### Board of Trustees Regular Meeting Agenda Hartland Township Hall Tuesday, June 21, 2022 7:00 PM

**Subject:** Site Plan Application #20-011 Villas of Hartland Planned Development (PD) –  
**REVISED** Preliminary Site Plan dated February 24, 2022

### **Site Plan Application #20-011 Villas of Hartland Planned Development (PD) –Revised Preliminary Site Plan (dated February 24, 2022)**

SITE PLAN

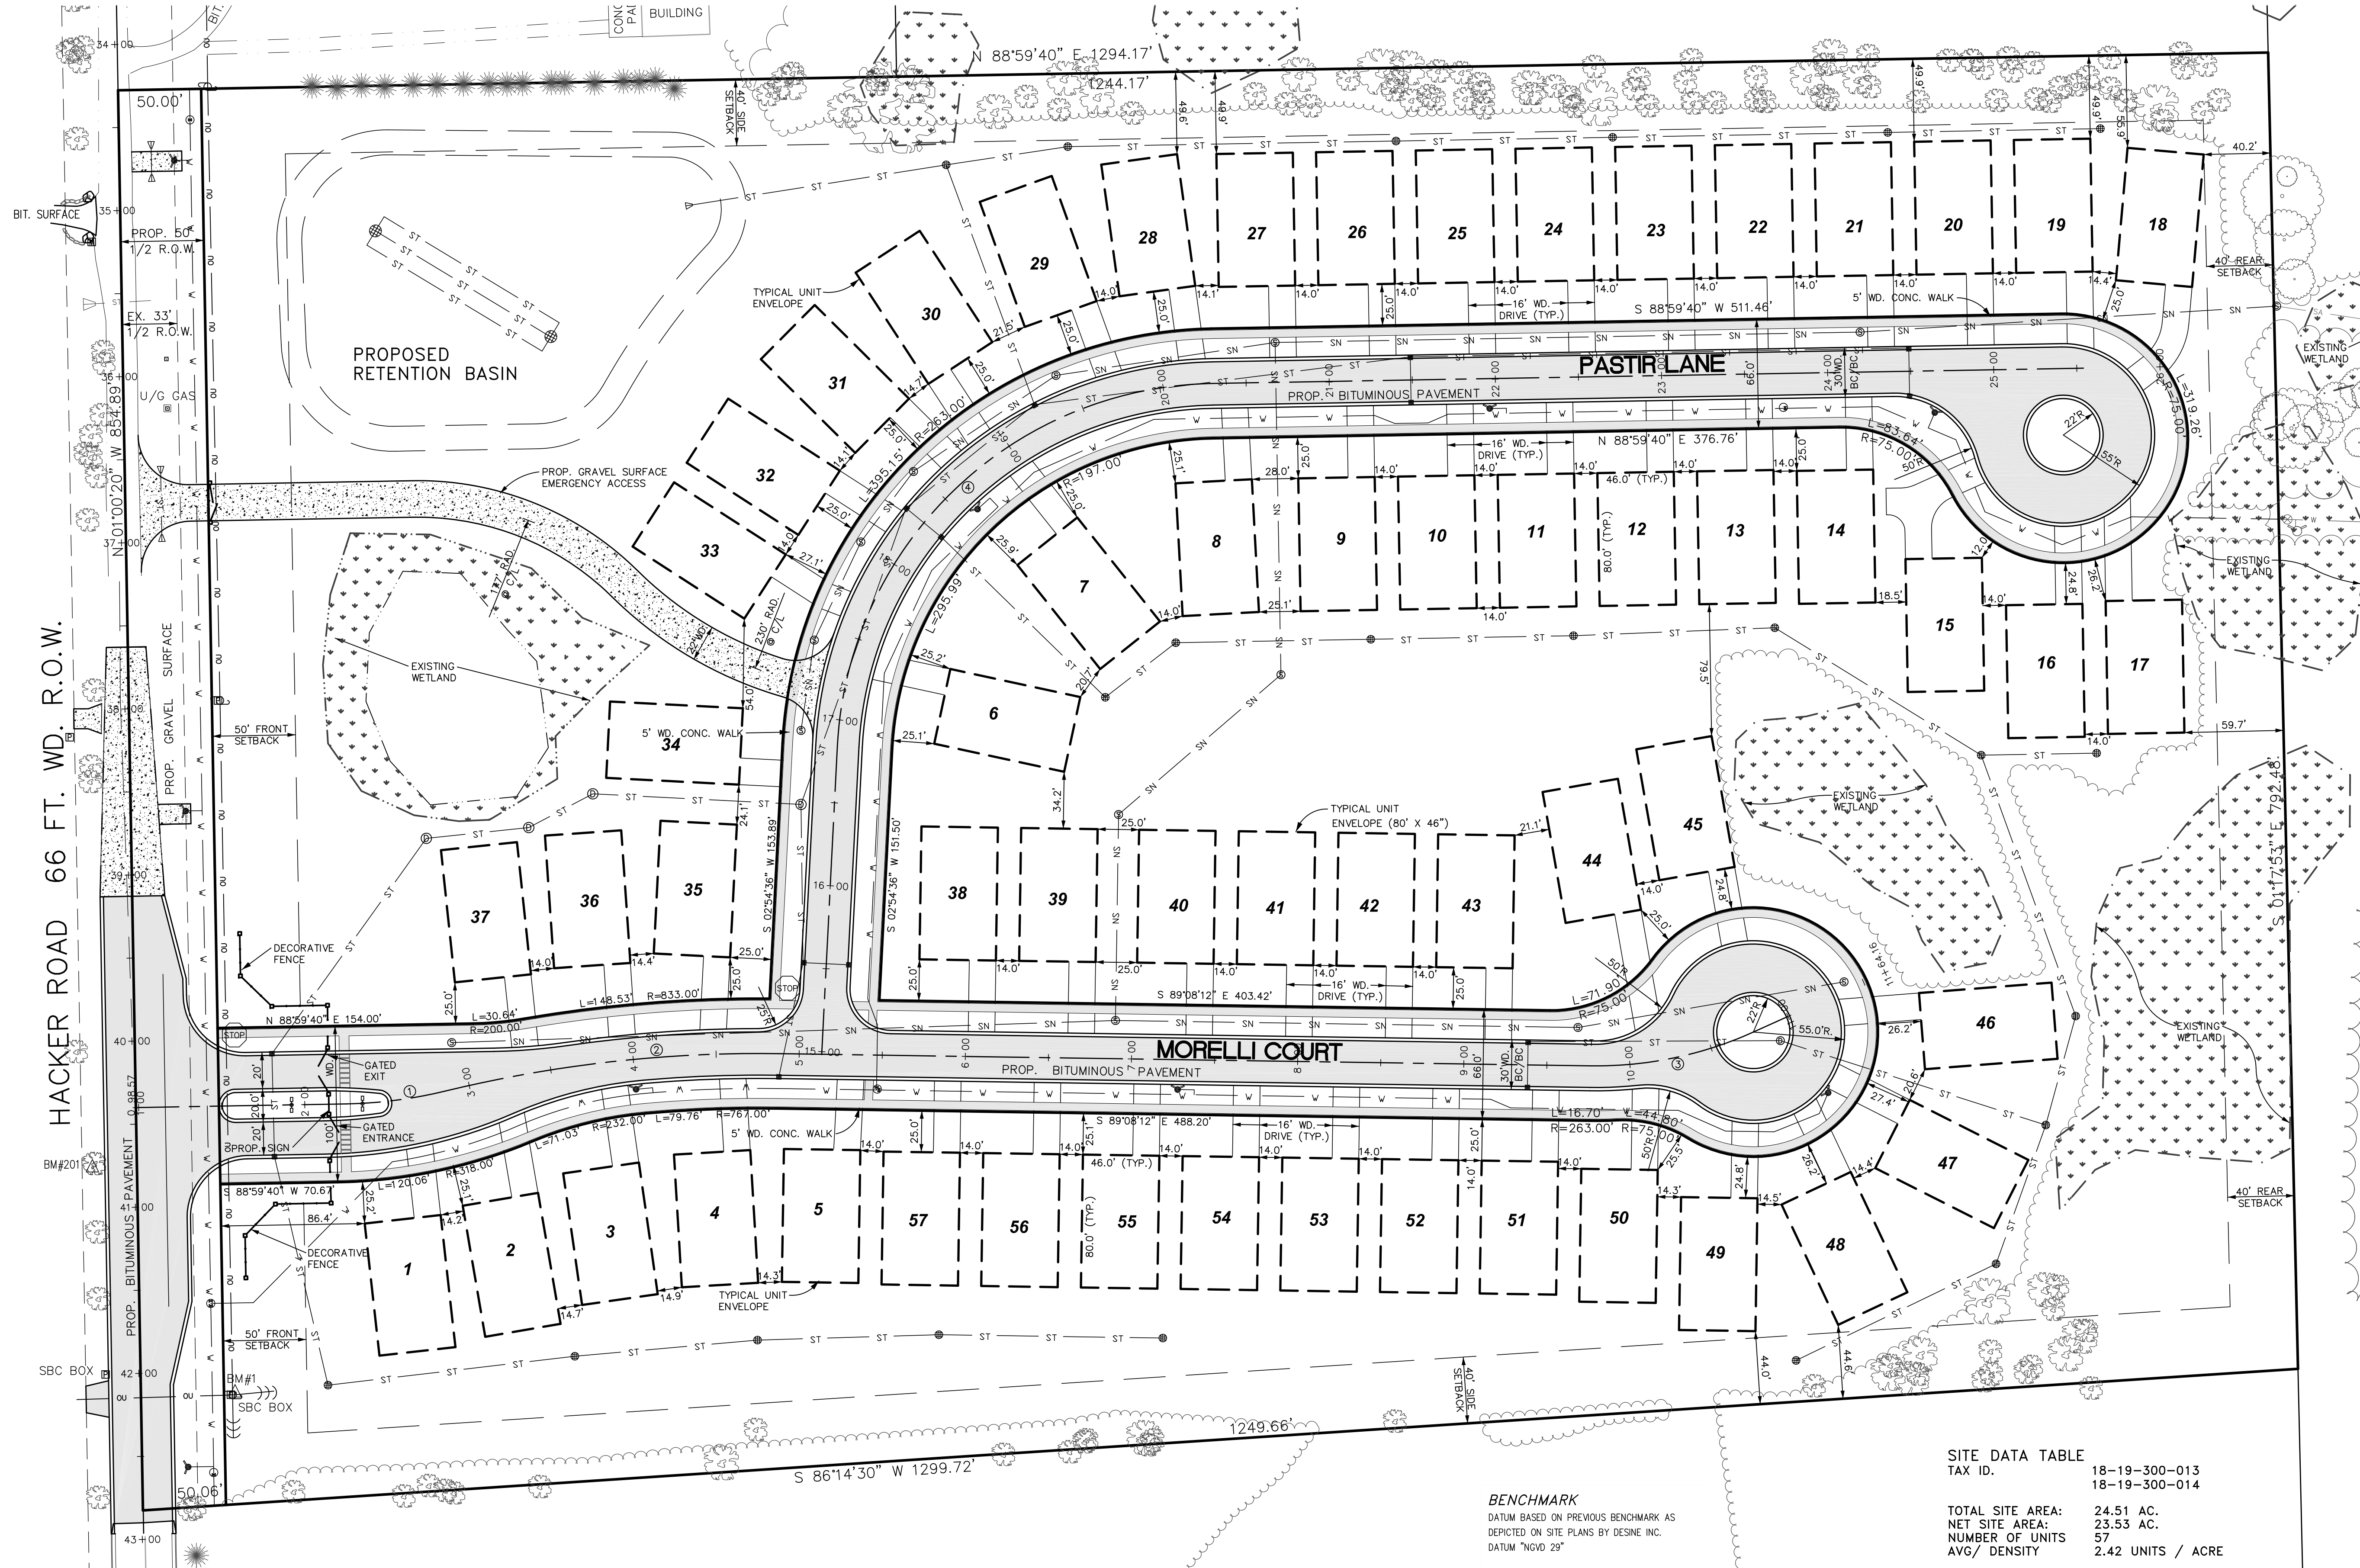
Public access to the development is via Hacker Road, with a boulevard entrance that is gated. Internal circulation is provided via private roads, with each road terminating in a cul-de-sac. A gravel surfaced, emergency access drive is proposed, from Pastir Lane to Hacker Road, on the west side of the site. The emergency access is gated at the Hacker Road right-of-way line and shown as twenty-two (22) feet wide. A detailed cross-section or profile drawing of the emergency access drive was not provided.

The residential units are shown with dashed lines and labeled as “Typical unit envelope.” The envelope dimensions are stated as 46 feet wide and 80 feet deep, or approximately 3,680 square feet (0.084 acres) in area. Building setbacks are not stated or shown, nor is the distance between buildings/structures. Staff assumes the intent of the proposed unit envelope is that each residential structure and associated accessory structures, including pools and sheds, will be located within the envelope; however, the applicant should provide clarification on this matter. Lot coverage within the unit envelope is not stated on the plans.

The distance between unit envelopes, at the closest point (front line facing the street), is generally fourteen (14) feet. Distances between unit envelopes vary at the side and rear sides of the envelope. The front setback along a street is not stated on the plan however most of the unit envelopes are placed twenty-five (25) feet as measured from the building envelope to the edge of the 66-foot-wide right-of-way private road easement.

The plan shows unit envelopes, within which all structures are to be located. Building footprints are not provided within the unit envelopes. The closest spacing between unit envelopes is fourteen (14) feet. If the house in each unit was at the unit envelope line, the distance between the structures could potentially be as close as fourteen (14) feet. This would not meet the minimum required spacing standards for single-family structures in a planned development. Per Section 3.1.18.C.vi.a., modification to yard setback requirements may be approved by the Township Board upon recommendation from the Planning Commission, upon making the determination other setbacks would be more appropriate.

**EMERGENCY ACCESS GATE DETAIL**  
NOT TO SCALE

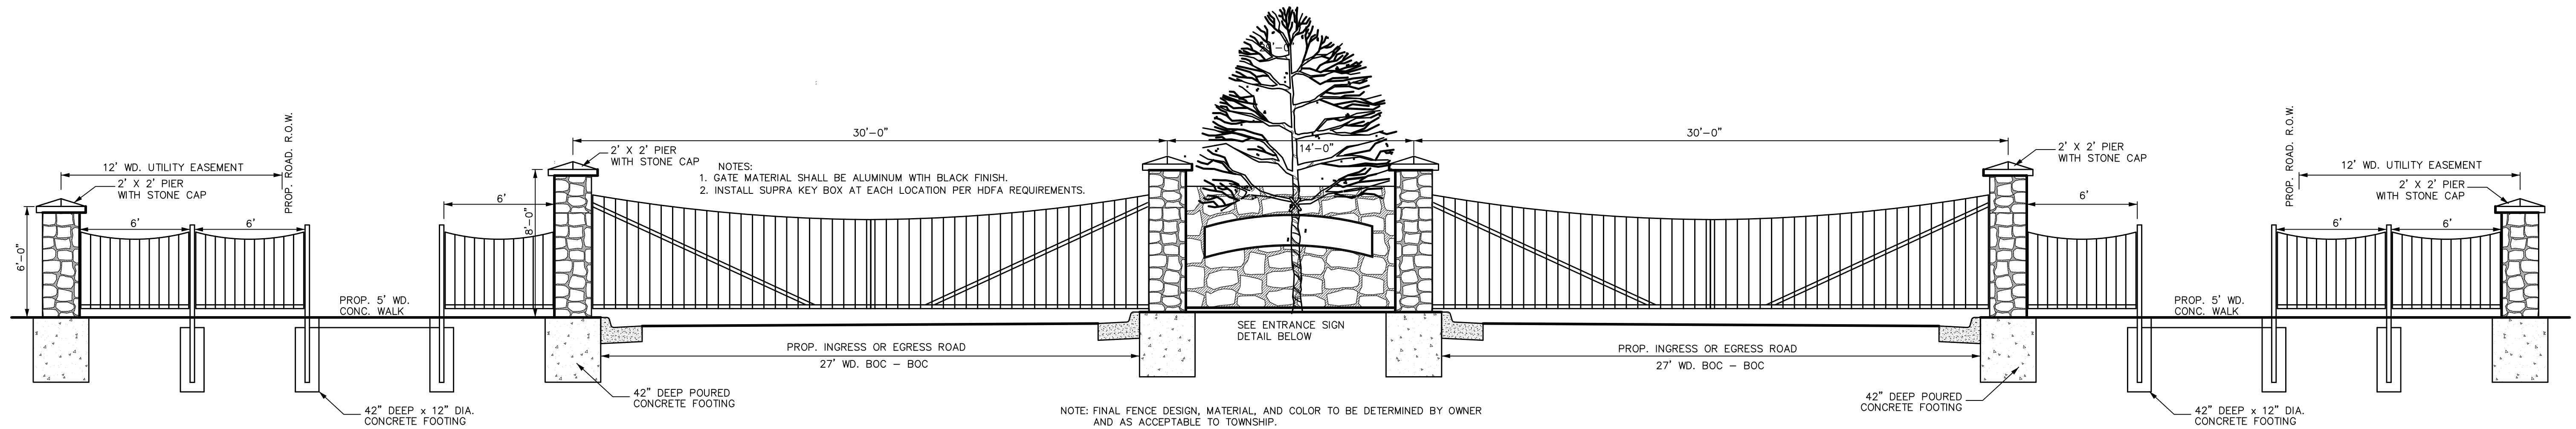
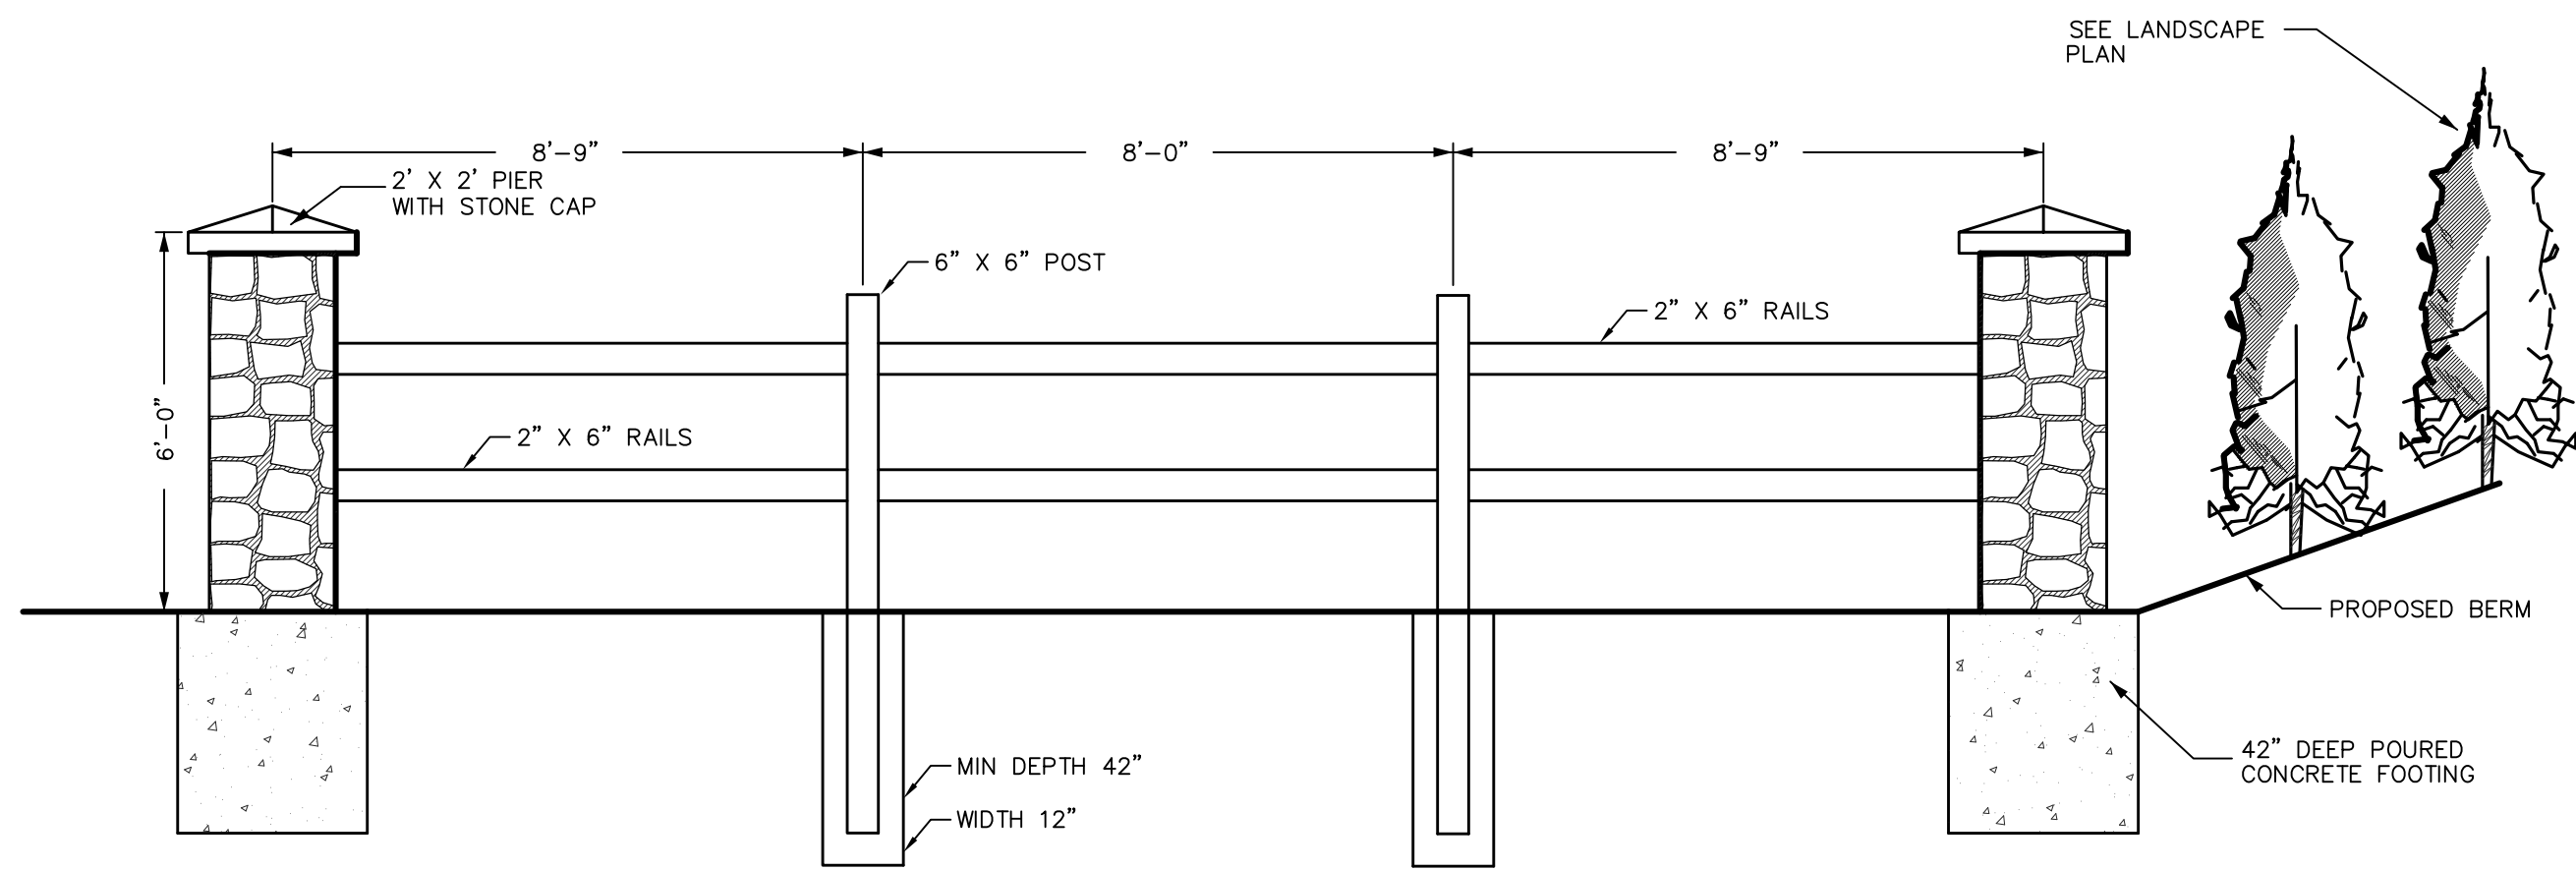
A gated, boulevard entrance provides access to the development via Hacker Road. A conceptual drawing is provided. Per the applicant the gates will be equipped with an electronic eye which will automate the opening and closing of the gates. The opening of the gates will be likely controlled by IR motion sensor or proximity loop in the pavement, per the applicant's explanation from the previous submittal. Details are not provided on the plans. Additional information will be required on how the gates for the emergency access drive operate. Clarification should be provided by the applicant and potentially be detailed in the Master Plan.
